**T-MOBILE SITE NUMBER:** DN06266A  
**T-MOBILE SITE NAME:** CO46077-A  
**T-MOBILE PROJECT:** SPRINT RETAIN

**SBA SITE ID:** CO46077-A  
**SITE ADDRESS:** 20359 INDUSTRY AVE. FOUNTAIN, CO 81008  
**JURISDICTION:** EL PASO COUNTY

TITLE SHEET

T-1

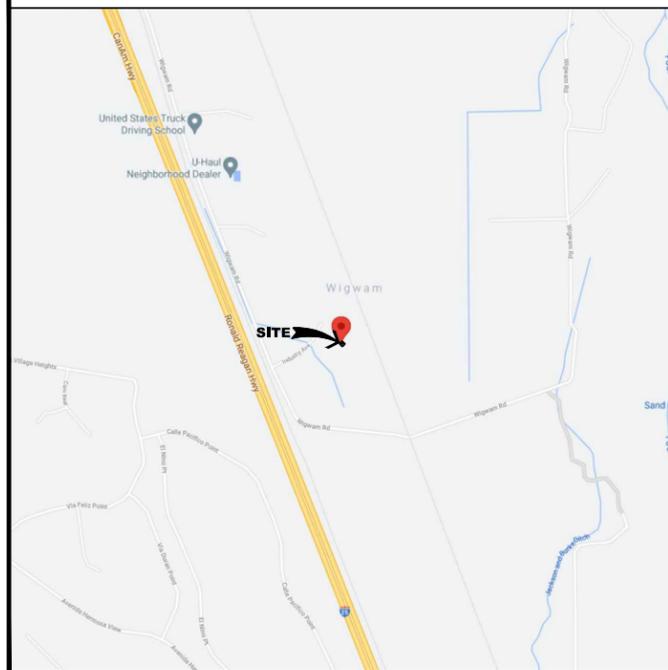
Signature block for the Planning and Community Development Director a minimum of 1 inch by 2 inches

Add property legal description and tax schedule parcel #

Add PCD File # PPR-2174 to all sheets
